Access Compliance Report

Public Rights-of-Way

(Curb Ramps)

Intersection ID: 47839	Main Street: PECO_RD	Cross Street: ALVARADO_WY	Location: NW
ADA ID: 17321AA2C394	Ramp Type: Perp	Initial Pass/Fail: Fail	Overall Compliance: No
Severity Score: 8.75			
Codes/Mitigation Info/Possible Solution		Field Measurements/Component Compliance

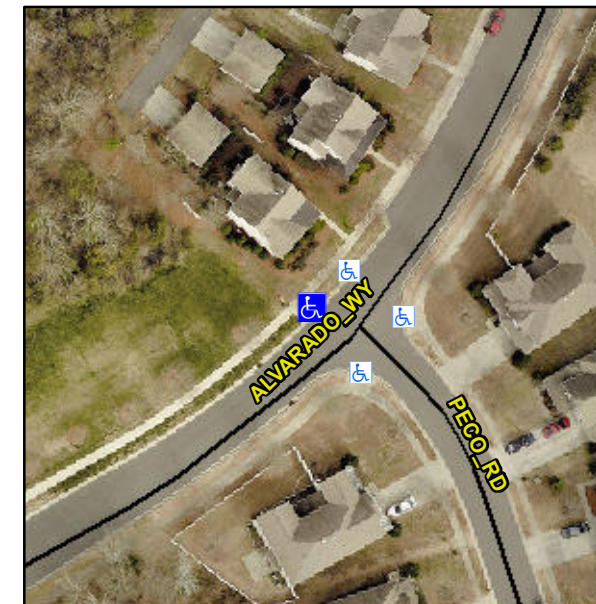
Compliance	Description	Data	Compliance	Description	Data
N/A	Ramp Length (in)	133.0	Yes	Ramp Slope (%)	7.3
No	Ramp Width (in)	47.0	Yes	Ramp XSlope (%)	1.0
N/A	Flare Type LT	N/A	N/A	Flare Type RT	N/A
N/A	Flare Slope LT (%)	N/A	N/A	Flare Slope RT (%)	N/A
N/A	Flare Traversable LT?	N/A	N/A	Flare Traversable RT?	N/A
N/A	Landing Length (in)	N/A	N/A	DWS Provided?	N/A
N/A	Landing Width (in)	N/A	N/A	DWS Contrast?	N/A
N/A	Landing Slope (%)	N/A	N/A	DWS Length (in)	N/A
N/A	Landing X Slope (%)	N/A	N/A	DWS Full Width?	N/A
N/A	Landing Curb? (Y/N)	N/A	N/A	DWS Offset (in)	N/A
N/A	Shared Landing?	N/A			
N/A	Gutter Ponding?	N/A	N/A	Gutter Slope (%)	N/A
N/A	Gutter Lip Ht (in)	N/A	N/A	Gutter X Slope (%)	N/A
N/A	Painted X Walk1?	No	N/A	Painted X Walk2?	N/A
	X Walk 1 Direction	To SE		X Walk 2 Direction	N/A
N/A	X Walk 1 Width (in)	N/A	N/A	X Walk 2 Width (in)	N/A
	X Walk 1 Slope (%)	3.1		X Walk 2 Slope (%)	N/A
	X Walk 1 X Slope (%)	1.2		X Walk 2 X Slope (%)	N/A

Remove & Replace Entire Ramp.
